City of Portland, Oregon
Bureau of Development Services
Land Use Services

**NOTICE OF A TYPE II DECISION ON A PROPOSAL IN
YOUR NEIGHBORHOOD**

**CASE FILE NUMBER: LU 09-105706 DZ, ROOFTOP ANTENNAE AND
MICROWAVE DISHES**

EAST ELEVATION

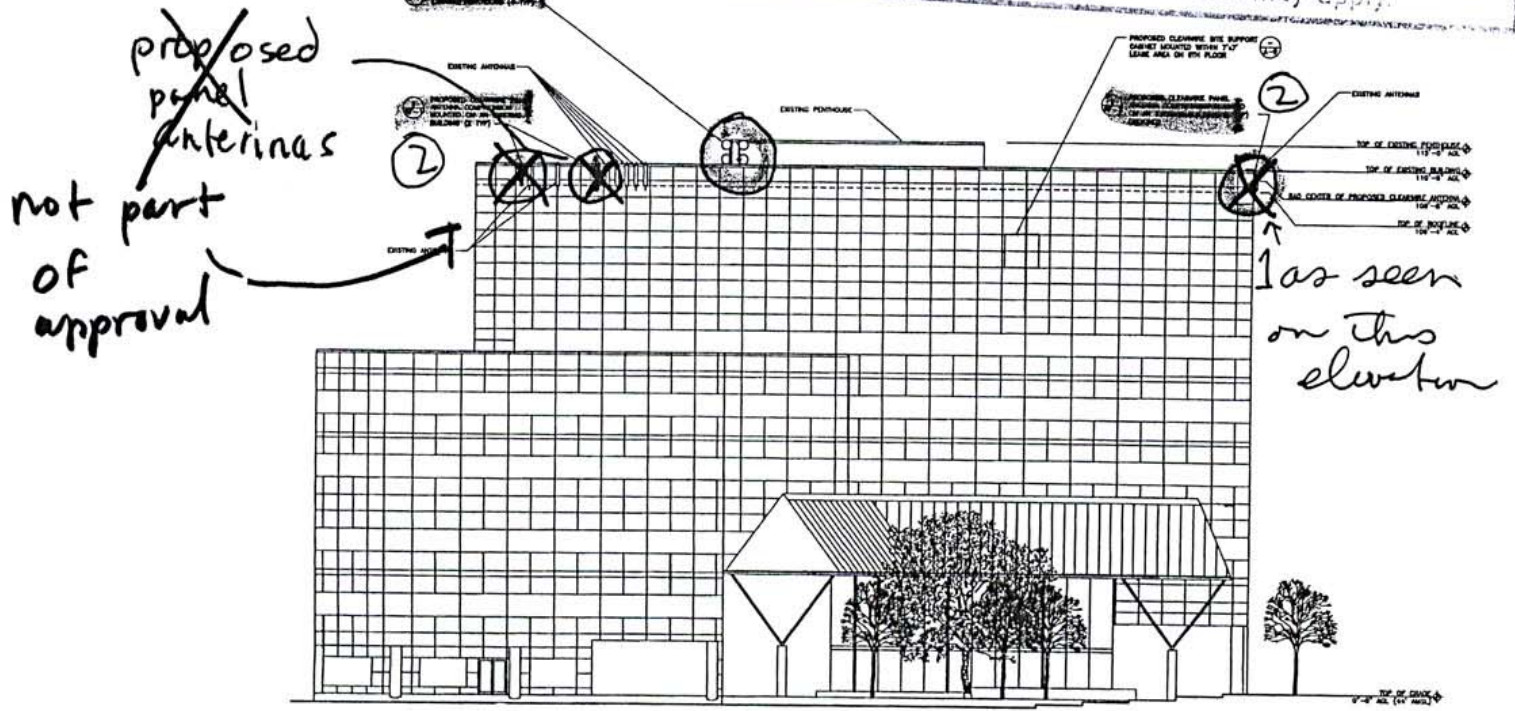
Upon viewing the existing panel antennae on the parapet, there is noticeable shadow lines due to the raised nature of the panels. The previous attempt to place parapet antennae to coincide with vertical material joint lines to mitigate for the appearance of the equipment does not represent a successful outcome, due to relief and shadow lines caused by the projection from the wall plane which interrupts the smooth, minimal wall and parapet qualities. In addition, the parapet currently includes 12 panel antennae; the proposal to add an additional 6 panel antennae to the parapet would provide further distraction to the smooth, planar architectural quality of the building, resulting in diminished integrity and cohesiveness of the building composition. The panel antennae proposed, and existing, is limited to the subject building within the ensemble. Although panel antennae exist on other buildings within the Central City Plan District, the prominence and location of the waterfront building on which the panel antennae are to be attached warrant further consideration.

A majority of the antennae reviewed by staff include rooftop mounted equipment. Certain mitigation measures allow unobtrusiveness, including the use of shrouds, location, height, or the employment of existing architectural features such as penthouses. A key mitigation measure is placement of the antennae away from the visible parapet edge, and from sight lines as viewed from the sidewalk level. The proposed location of the panel antennae does not allow similar mitigation measures in order for the equipment to blend into the existing architecture. The score lines and location on the building do not provide a significant measure of mitigation. In addition, due to lack of maintenance of the existing panel antennae, the paint layer which allowed some blending into the skin of the architecture has been lost, resulting in a contrast between the exposed, shiny metal and the granite veneer. The microwave dishes proposed will be placed on an existing penthouse, which is centrally located approximately 30'-0" away from the north elevation wall and 45'-0" away from the east elevation wall. The dishes will be painted to match the existing penthouse, and will not interfere with any major architectural features of the building.

If another solution were found in which the panel antennae were adequately set back from the edges of the building and screened by appropriately sized shroud enclosures, or were integrated with the building by attaching to the building's existing penthouse at a reasonable height, this guideline could be met. The shrouding method should demonstrate a blending with the architecture as closely as possible, in regards to color, materiality, size, and massing. The applicant must show how this will be achieved with appropriate sample materials, drawings, and details. ***As currently proposed, this guideline is met for the microwave dishes, however this guideline is not met for the panel antennae. With further study of antenna locations and shroud methods, this guideline could be met for the panel antennae.***

Denial of 6 new panel antennae on the parapet located at 26 SW Salmon Street, in the Central City Plan District.

SOUTH ELEVATION

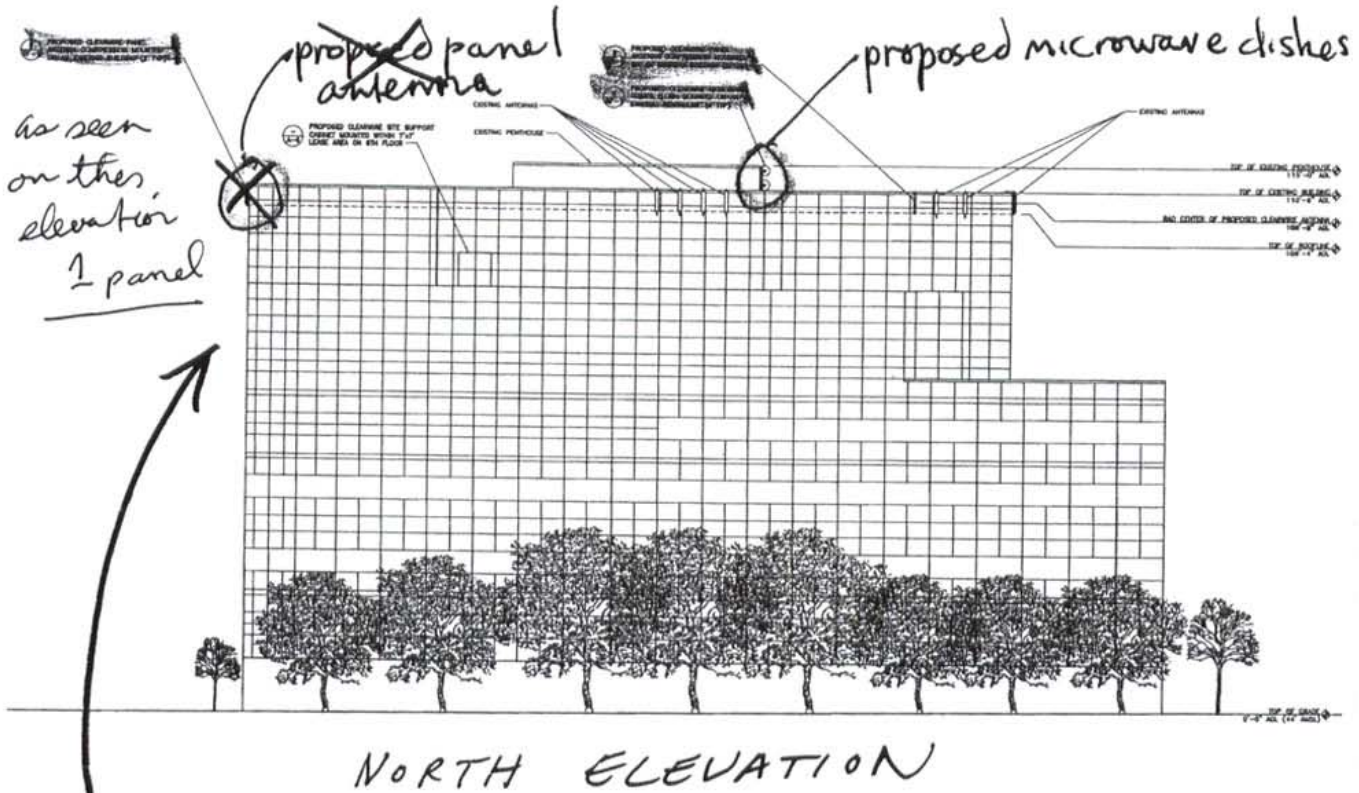
not part of approval
